Planning Commission Meeting Agenda

Tuesday, September 18, 2018, 5:30 PM

1. Noble House Addition, Restoration, Change of Use, and Landmarking (CL) 213 S. Ridge St.; PL-2018-0069 6

Subject: Noble House Restoration, Addition, Change of Use, and Landmarking
(Class B Minor Historic, Final Hearing; PL-2018-0069)

Site Plan Landscape Plan
Scale 1/8" = 1'-0"

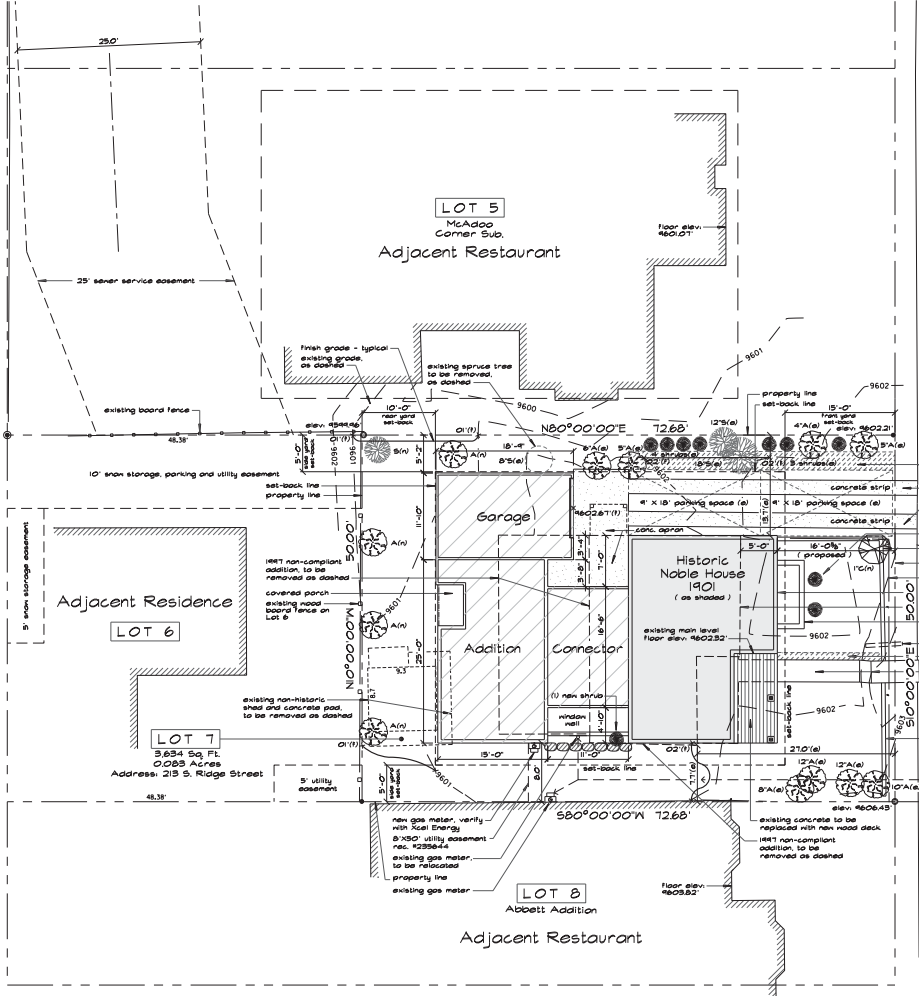
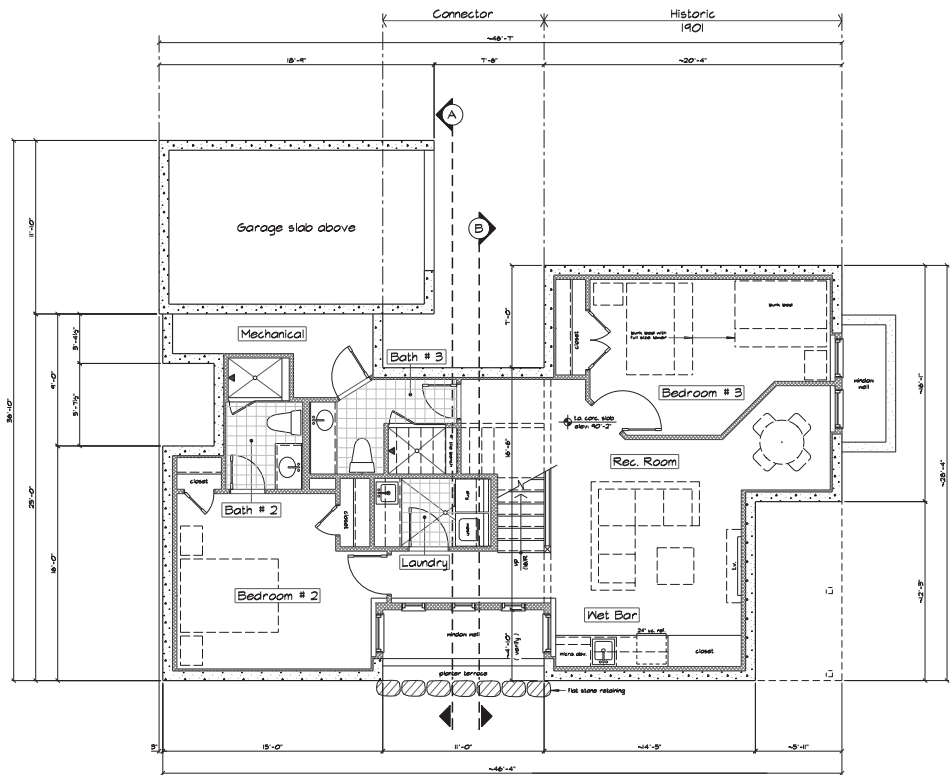
Snow Removal and Storage (13/A & 13/R): The proposed site plan now designates snow storage for the front walkway.

- 14 sf. snow storage, as hatched
- remove and replace existing parking strips as hatched
- 12' new shrubs to screen window wall
- existing wood tie retaining wall
- 3" wrought iron fence
- proposed house location
- existing house location per survey
- window well
- existing sign to be removed, as dashed
- 14 sf. entry path snow storage, as hatched
- existing flagstone walk and steps to be replaced as required
- concrete sidewalk
- curb & gutter (2" pan)
- existing wood tie retaining wall
- existing gas line to Lots 7 & 8 (e) per utility locate (verify)

NOBLE HOUSE : RESTORATION

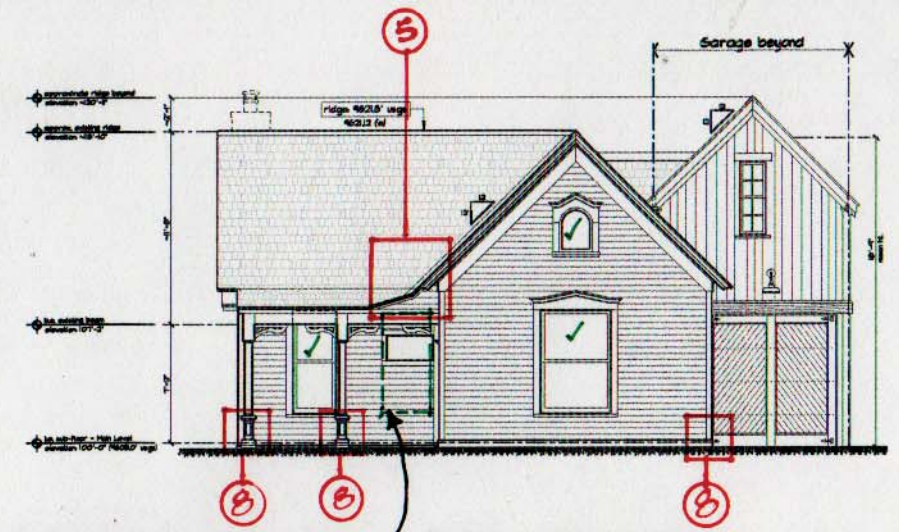
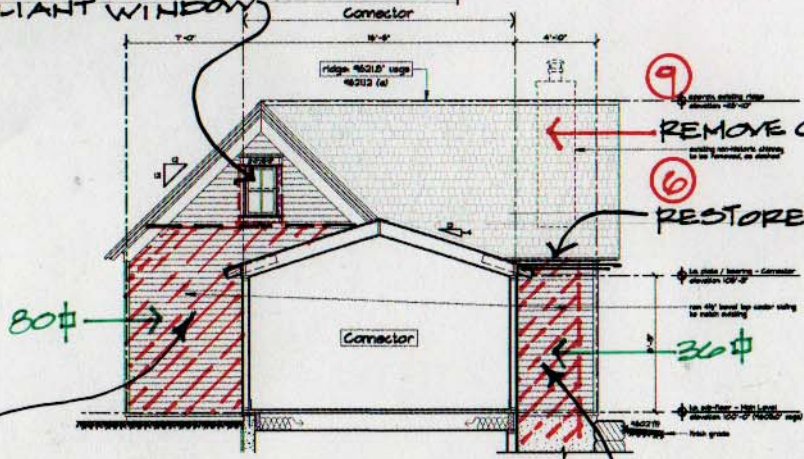
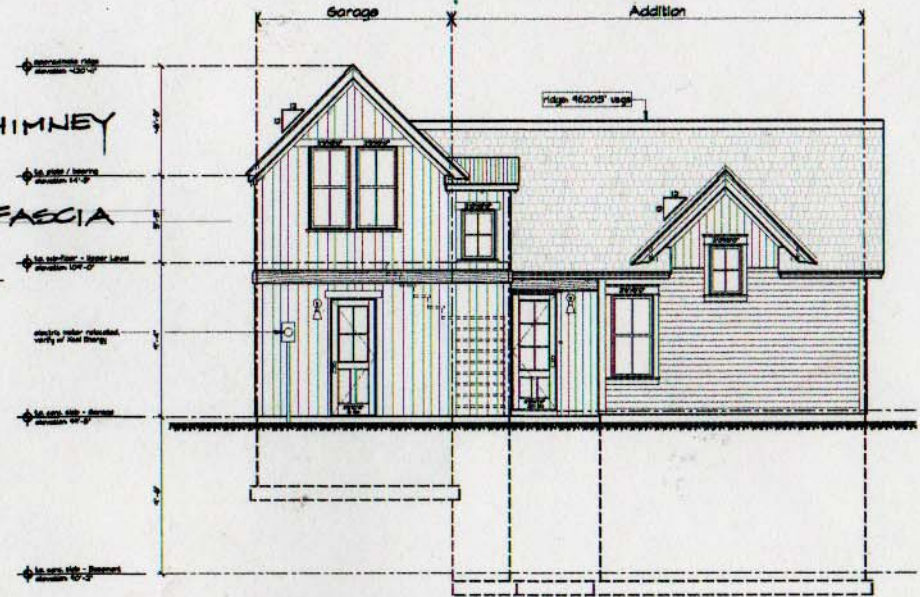
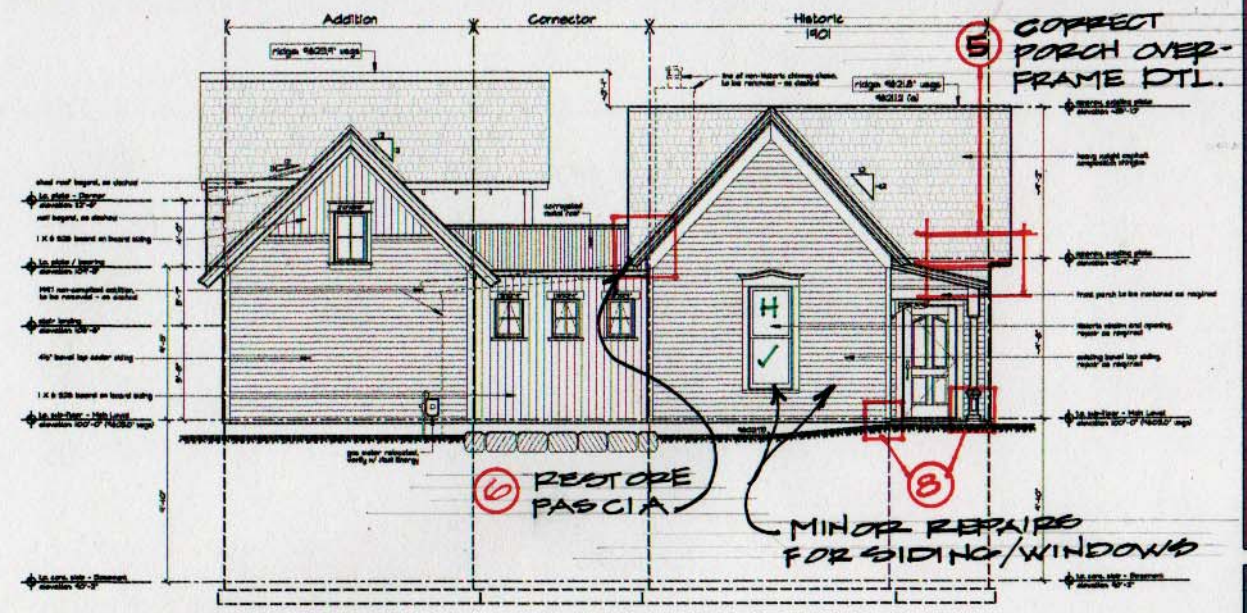
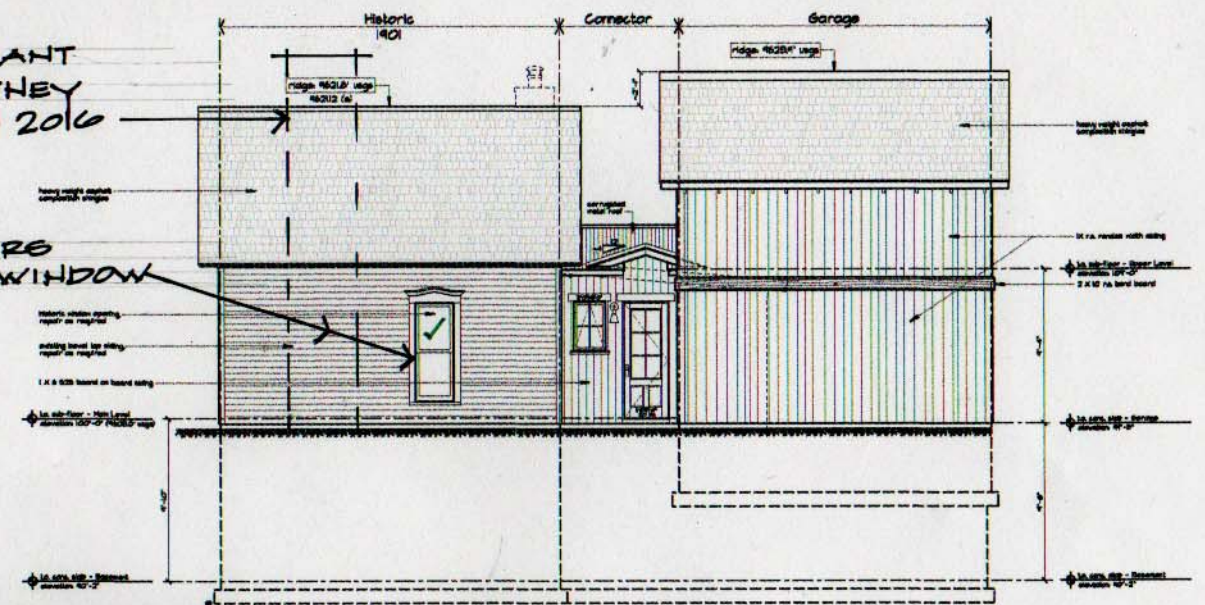
LARGE EXISTING WINDOW
TO BE REPLACED W/ HISTORICALLY
COMPLIANT WINDOW

9 REMOVE CHIMNEY
6 RESTORE FASCIA

INTERNALLY BURIED HISTORIC WALL
TO BE INTRODUCED & RESTORED
ONCE EXISTING ADDITION IS REMOVED
